### **Report of the Joint Meeting of Experts on the Regulations annexed to the European Agreement concerning the International Carriage of Dangerous Goods by Inland Waterways (ADN Safety Committee) on its thirty-second session\***

#### **Addendum**

### Proposed amendments to the Regulations annexed to ADN for entry into force on 1 January 2019

### Classification of zones for tank vessels

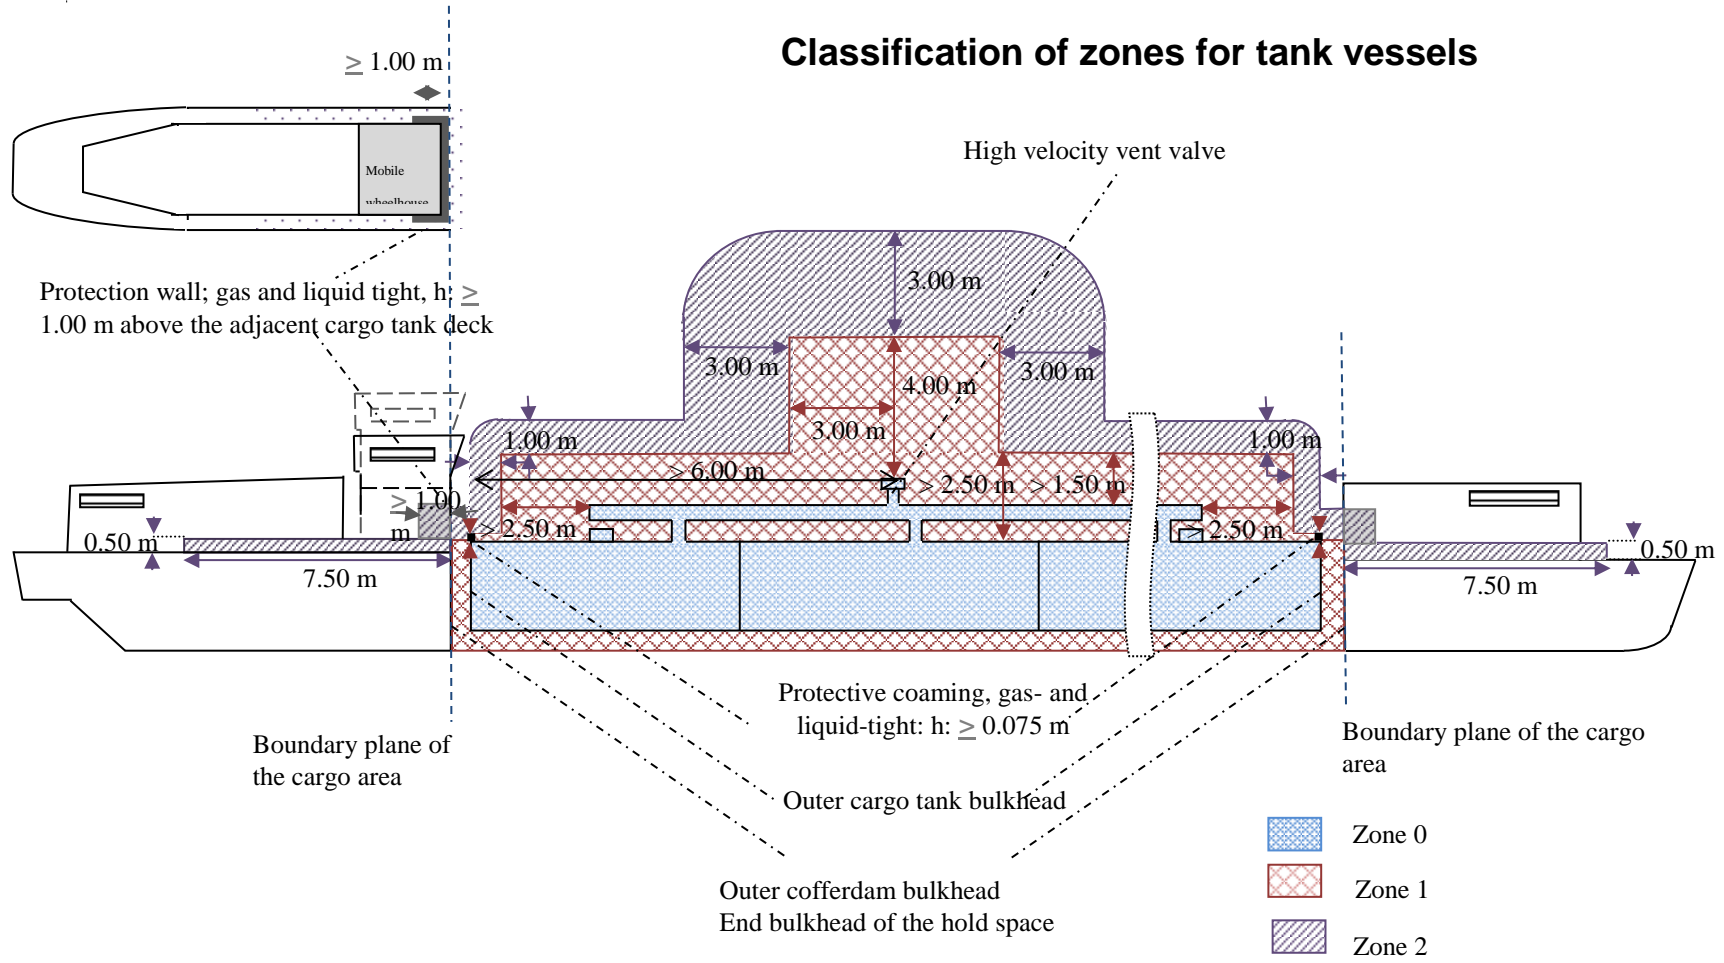
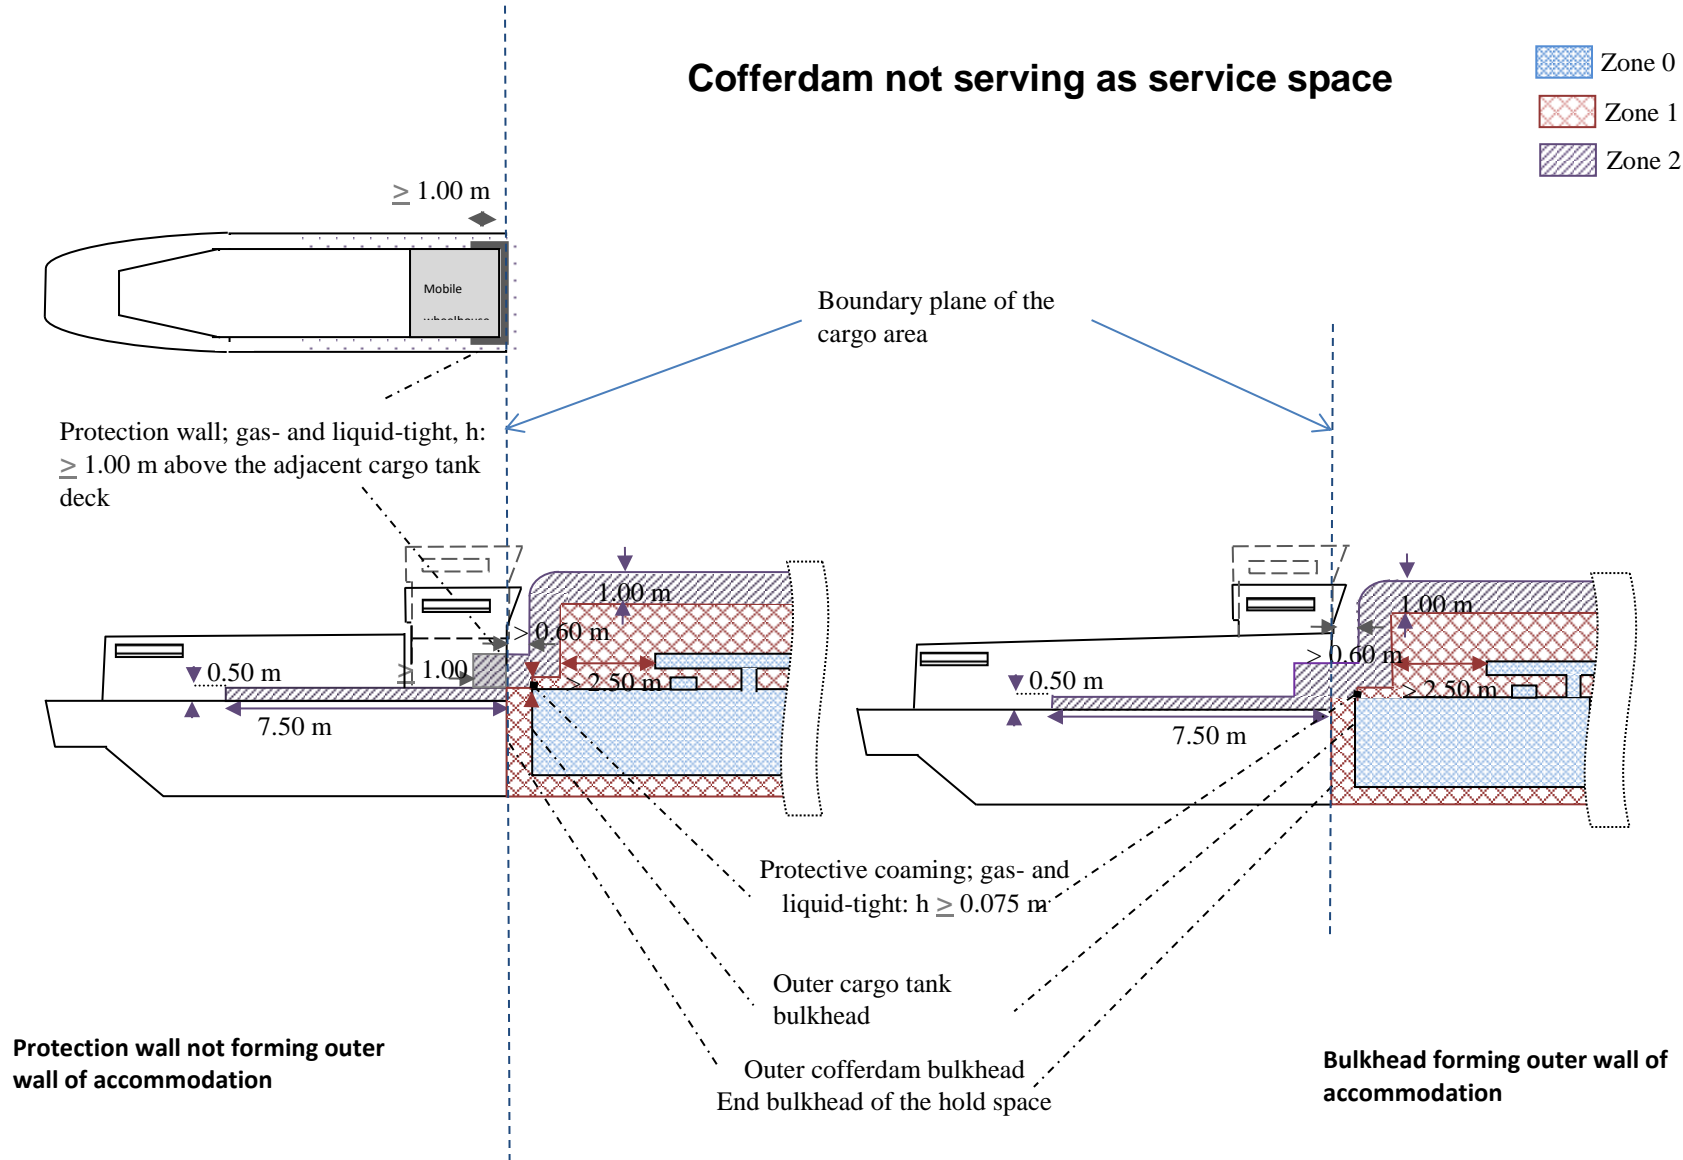
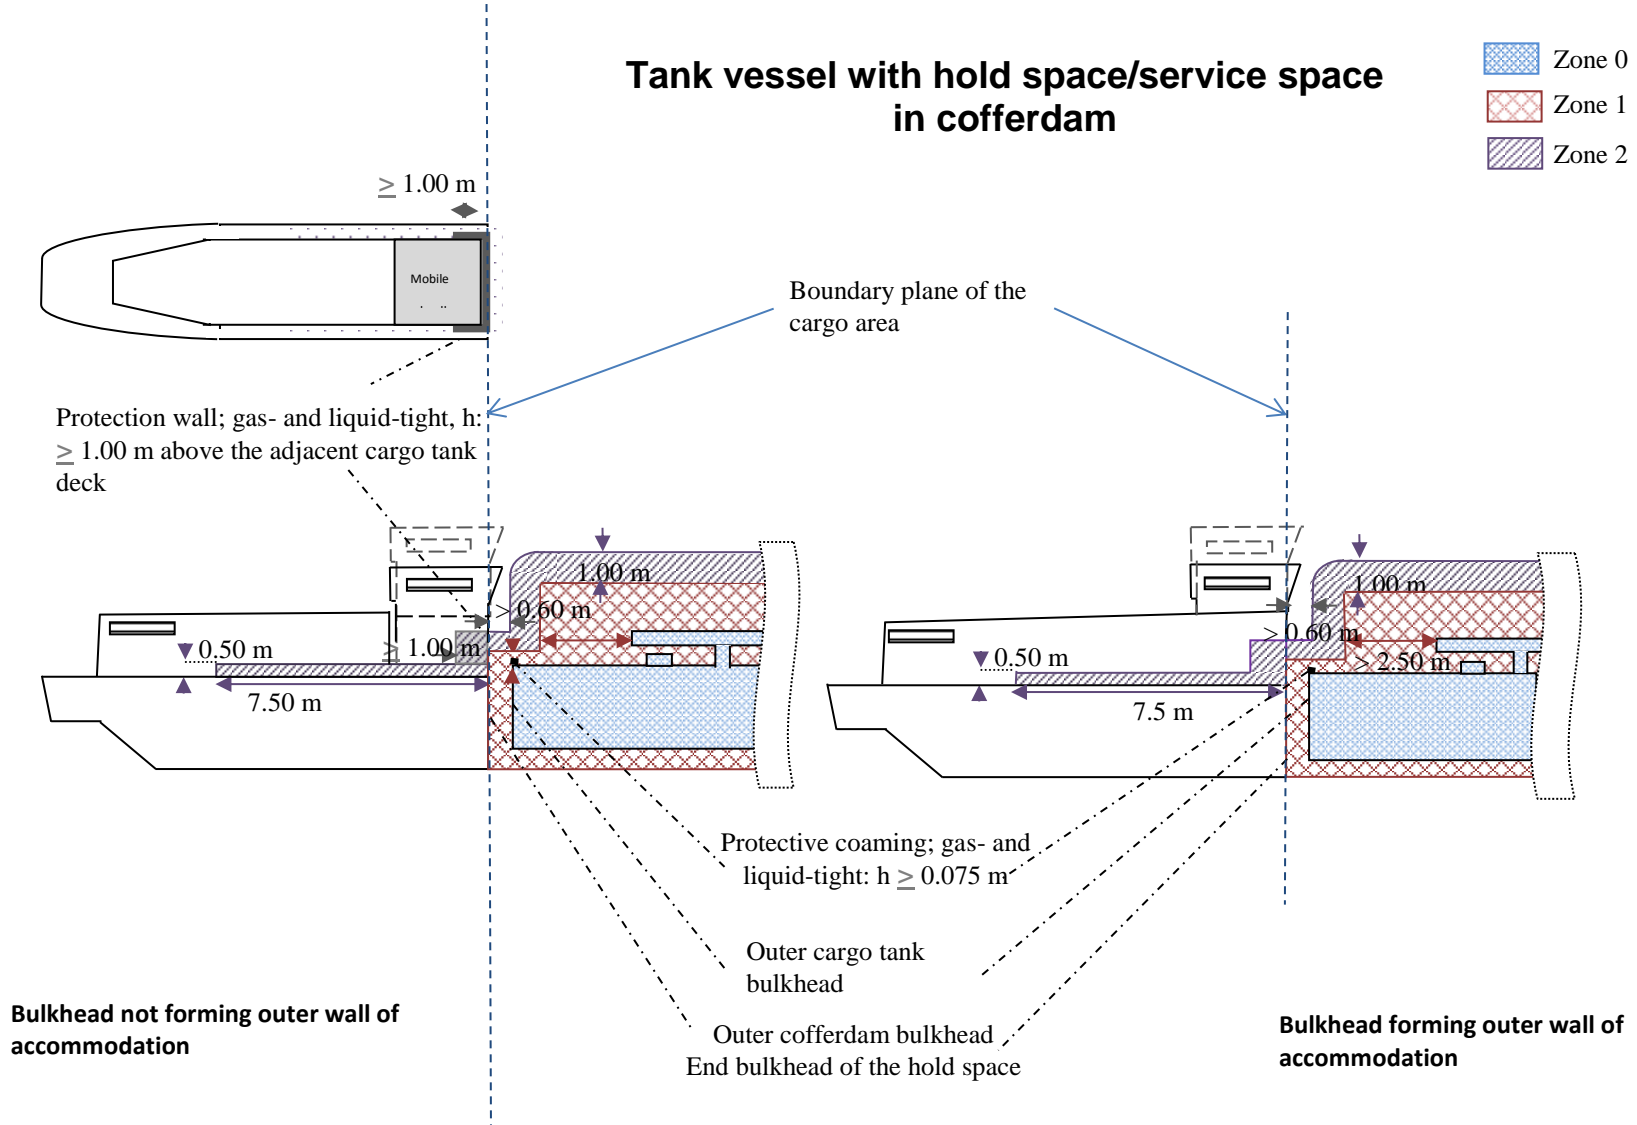
- Closed spaces on deck within the cargo area.
- The deck in the cargo area over the entire width of the vessel to the outer cofferdam bulkheads.
- Up to a distance of at least 1.60 m to the “boundary planes of the cargo area”, the height above the deck is 2.50 m, but at least 1.50 m above the highest piping carrying cargoes or cargo vapours.

If the ship is built with hold spaces or a cofferdam/part of a cofferdam is arranged as a service space, the adjacent height (fore and aft) to the “boundary plane of the cargo area” is 1.00 m above deck (see diagram).

- On the deck in the cargo area, a zone extending 1.00 m upwards and sideways longitudinally from zone 1.
- On the fore deck and the aft deck, an area 7.50 m in length across the entire width of the vessel and adjacent to the “boundary plane of the cargo area”. Between the lateral side of the vessel and the protection wall, the length and height of this area equals the dimensions of the lateral side of the protection wall. Elsewhere, the height in zone 2 is 0.50 m.
